Our Case Number: ABP-317742-23

Re: BusConnects Bray to City Centre Core Bus Corridor Scheme
Bray to Dublin City Centre.

Observation on a Strategic Infrastructure Development Application

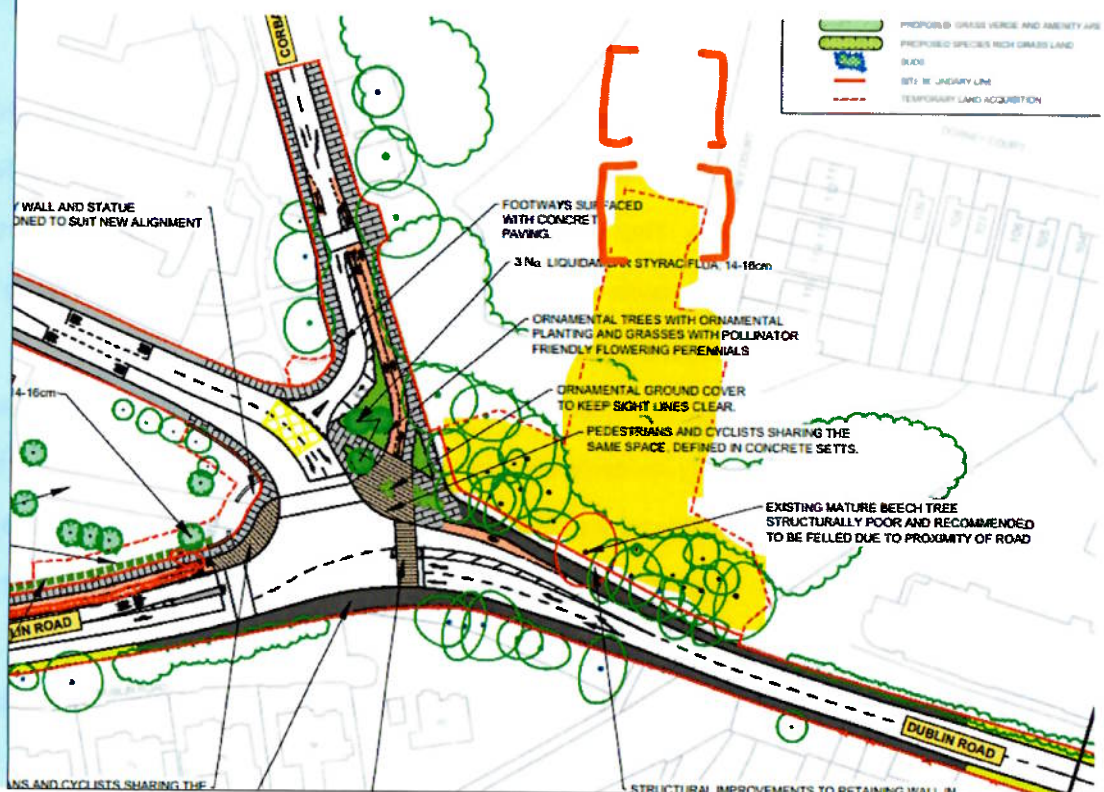
Additionally, the plan requires the removal of the roundabout Cherrington Road and Quinns Road.

This roundabout is used by residents who would proceed through the village and used this roundabout to u-turn to come back to the village for amenities use such as the shops, post office etc.

Again, it's obvious to residents that the removal of this roundabout would mean an increase in u-turns within the village area.

The removal of these roundabouts would supply little benefit to the overall plan and likely would adversely affect the throughput of busses.
